Subject: NABI Safety Recall #20101

VEHICLE DEFECT
INITIAL INFORMATION REPORT

NABI Recall No. 20101

Eaton Hydraulics Business Service Bulletin

Eaton / Vickers MCD 8913 (assembly #02-201127)

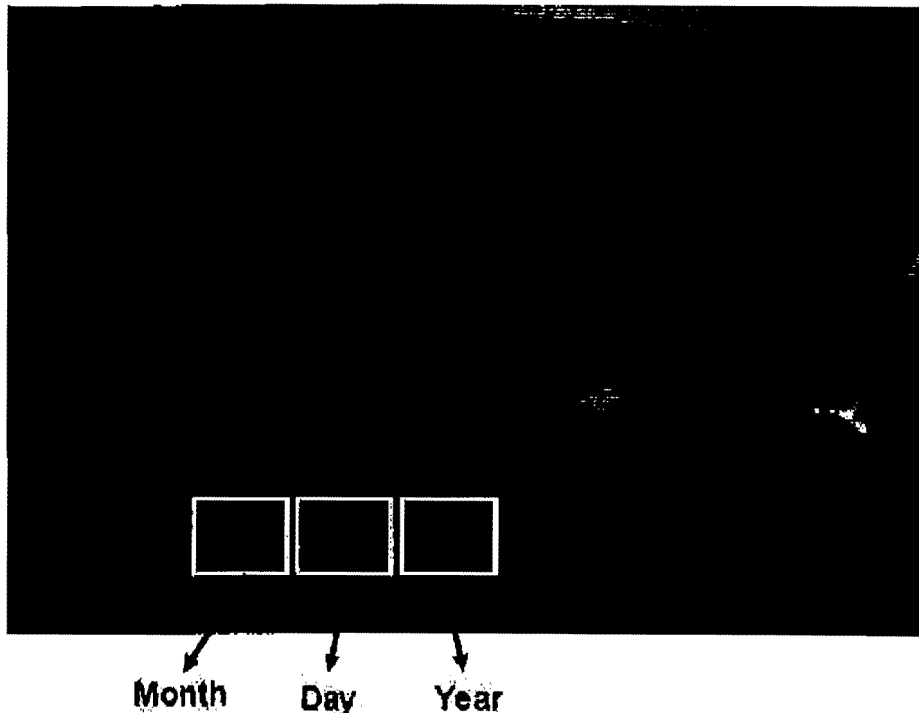
Eaton's Hydraulics Operations has detected a potential quality issue with fan drive controlled manifold MCD 8913 (assembly # 02-201127). Pinhole defects in the aluminum body could develop which may cause the manifold to leak.

Below is an example product identification label that lists the manufactured date at the bottom of the label and the product revision level.

*** Please note that manifolds with the revision level of H (as pictured here) are not affected by this recall.**

Eaton has taken the appropriate steps to correct this issue by supplying the manifold with a valve featuring a diffuser ring.

Replacement manifolds identified with Eaton assembly number of 02-201127 MCD-8913
Revision H will be made available.
